LCCU New Bern

ADDENDUM

3

RE: LCCU - New Bern: RFI 8.3.2022

A602

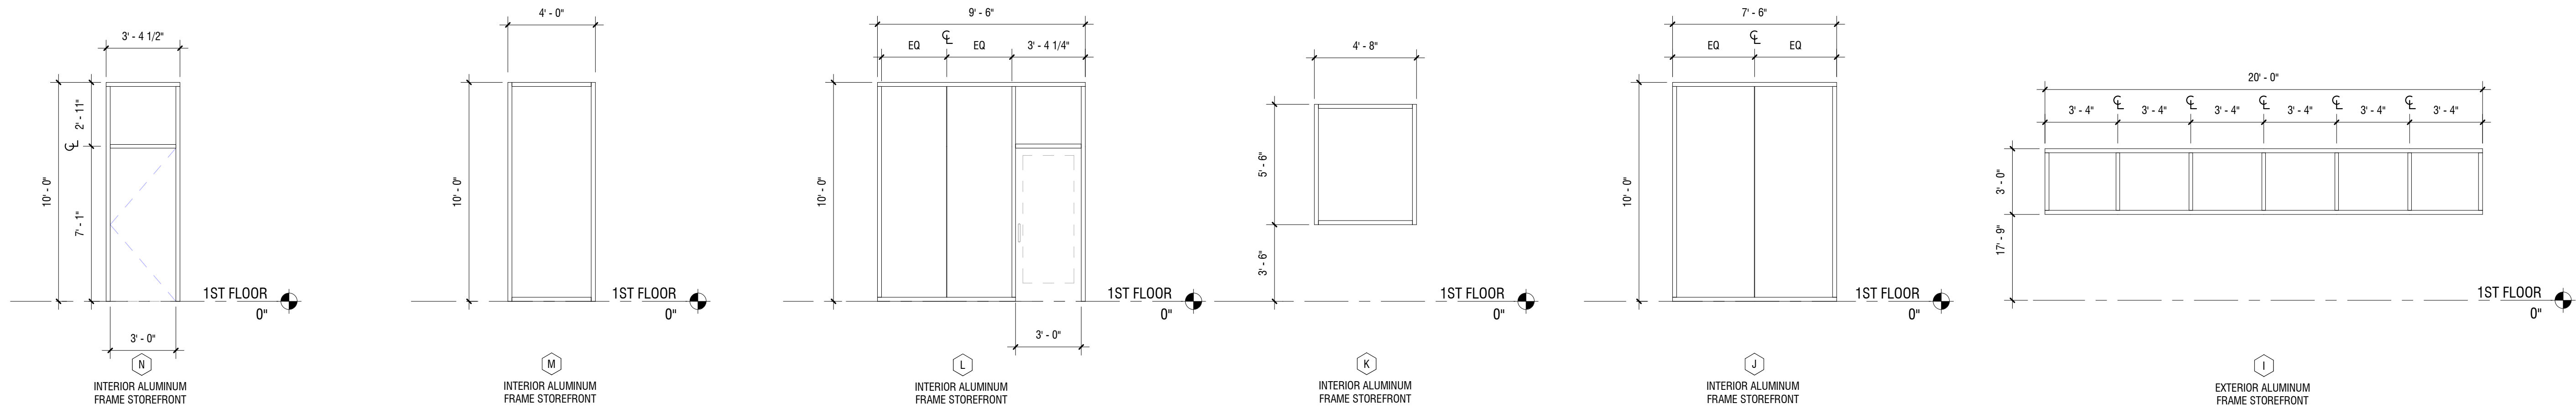
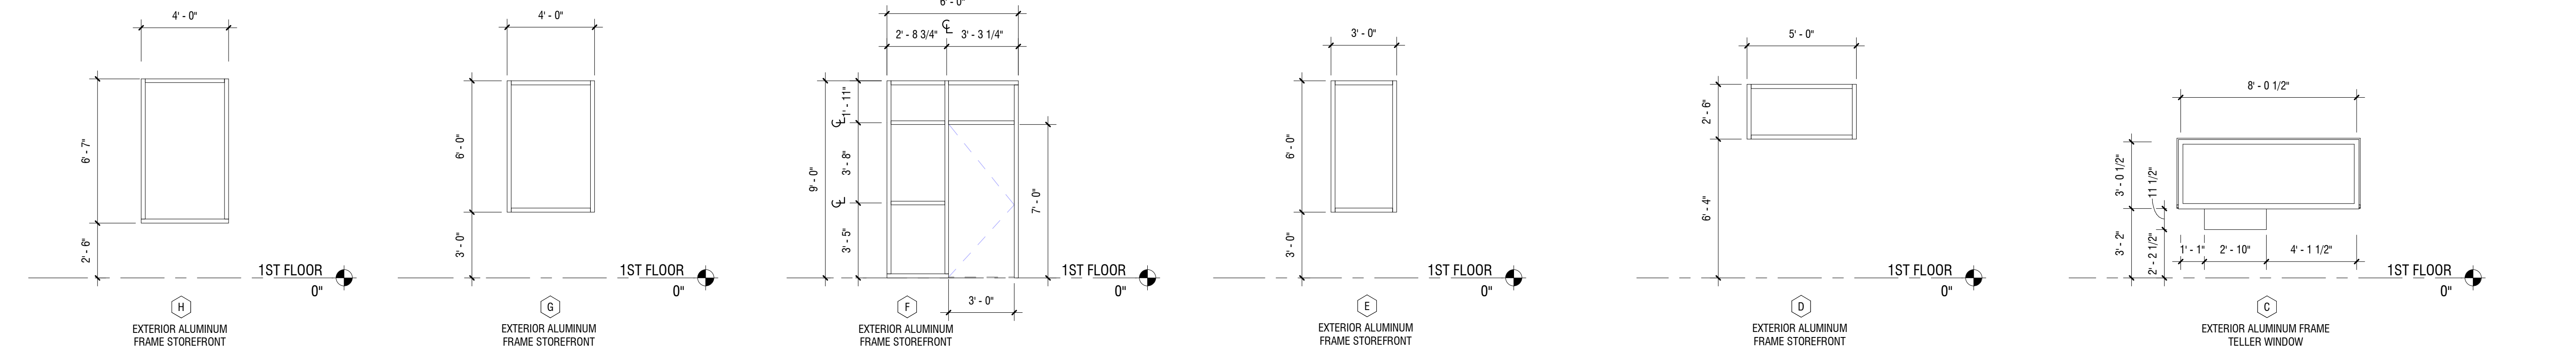
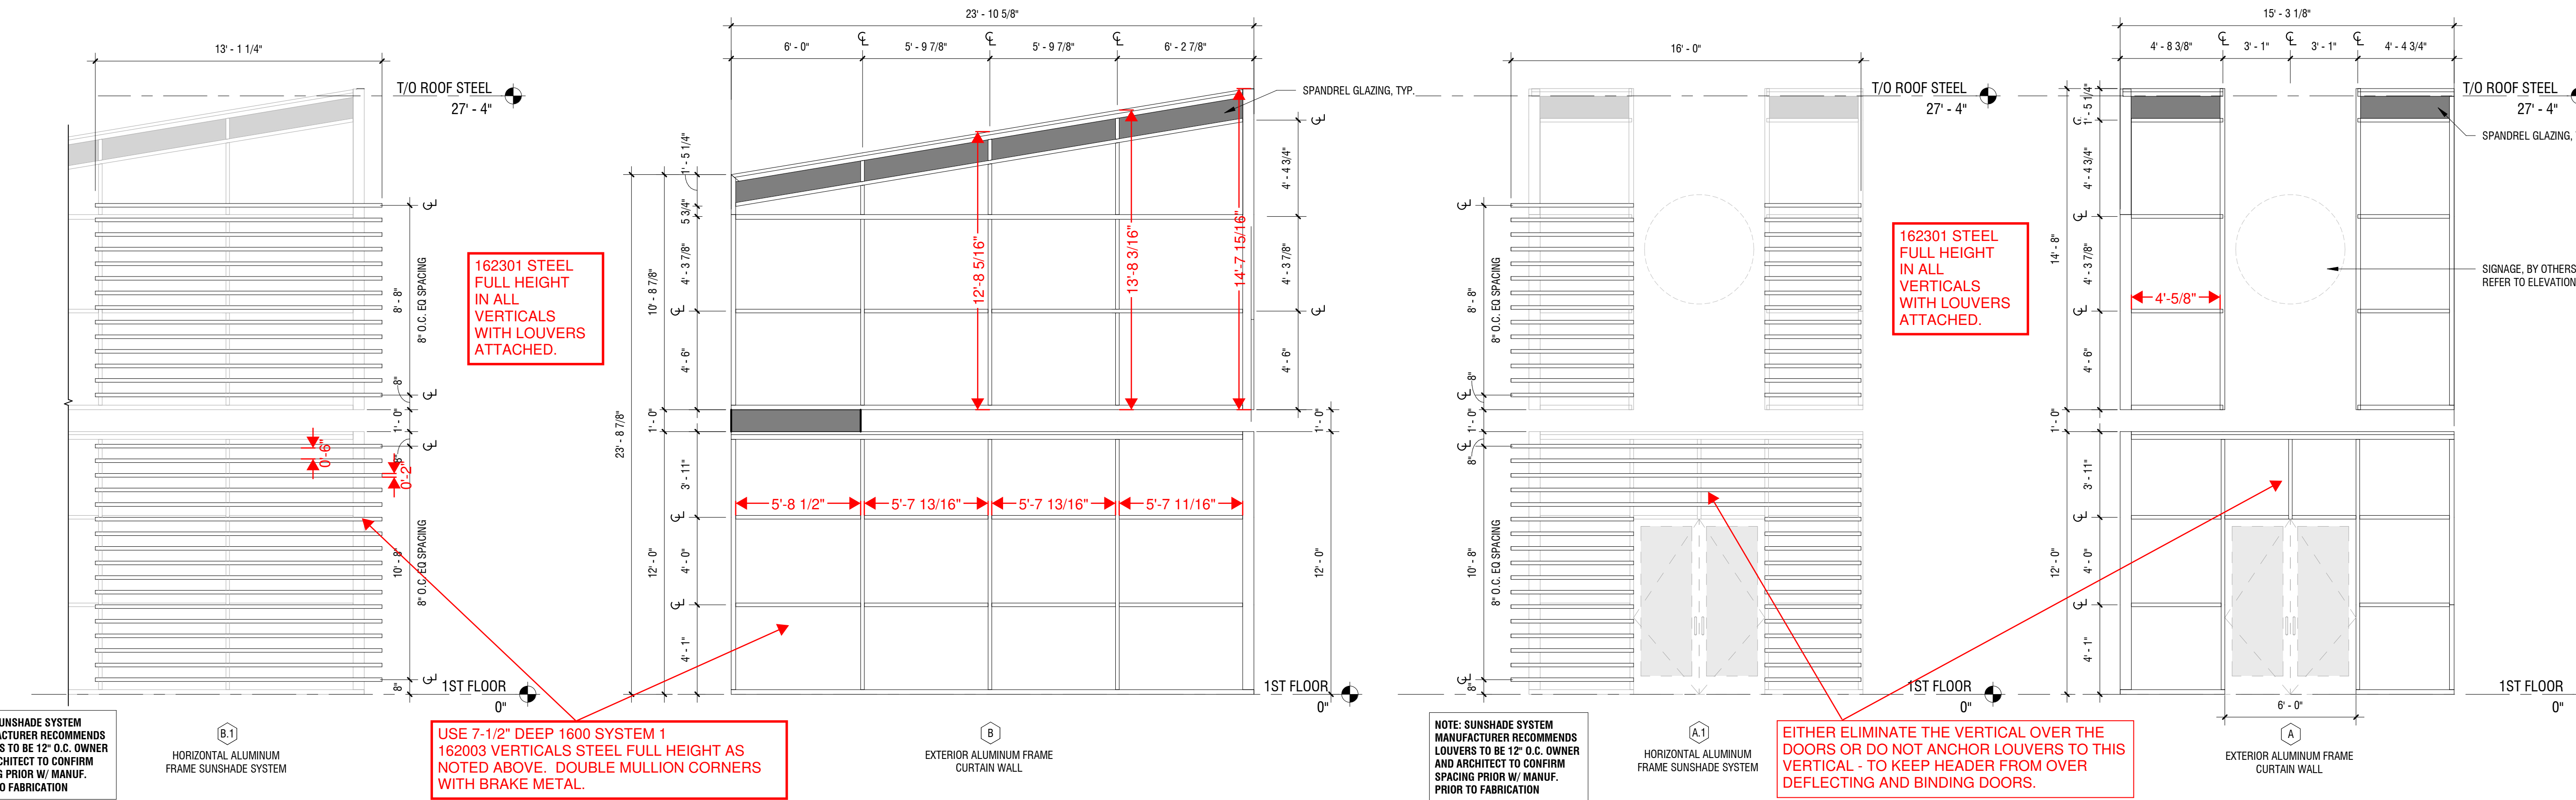
- a. Preliminary detail provided by Kawneer + Longboard
11. The louvers or Longboard shades are spaced 8" o.c. vertically. There is a note referring to 12" o.c. spacing on elevation 2/A602. Where does the 12" o.c. refer to?

REVIEW BY: TIM WASHBURN 7/22/22
REVIEWED ELEVATIONS A, A.1, B, AND B.1
WL ZONE 4 = +19 PSF / -20 PSF
WL ZONE 5 = +19 PSF / -25 PSF

USE 7-1/2" DEEP 1600 SYSTEM 1 162003 VERTICALS STEEL FULL HEIGHT AS NOTED ABOVE. DOUBLE MULLION CORNERS WITH BRAKE METAL.

162301 STEEL FULL HEIGHT IN ALL VERTICALS WITH LOUVERS ATTACHED.

EITHER ELIMINATE THE VERTICAL OVER THE DOORS OR DO NOT ANCHOR LOUVERS TO THIS VERTICAL - TO KEEP HEADER FROM OVER DEFLECTING AND BINDING DOORS.

- a. Disregard 12" o.c. note
12. Who is responsible for window elevation type C (teller window) if glaziers are responsible for this and not the owner, we will need a full spec section along with a basis of design

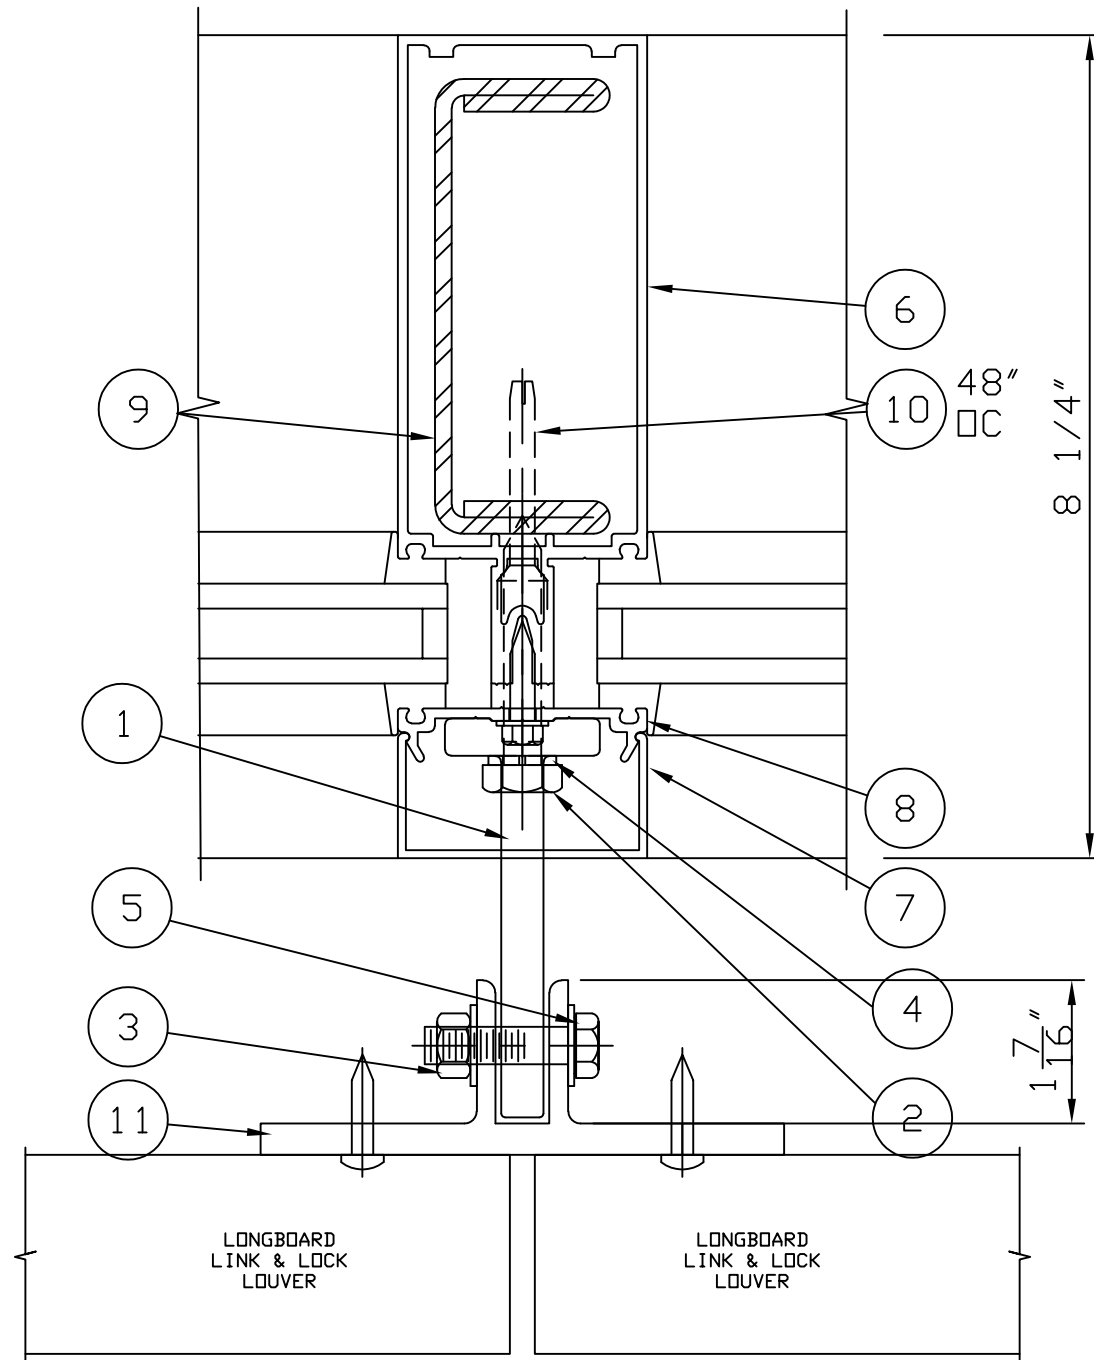
- a. Disregard
10. Are there any details for the attachment of the longboard Link & Lock sunshade system shown in the elevations on sheet A602. Section 7/A503 shows the louver in mid-air. If the louver slates are attached to the aluminum storefront material the storefront manufacturer may have issues with us attaching to their system when it comes to finish warranties, weather tightness and design loads. A separate framing system independent of the storefront system may be needed for the louvers
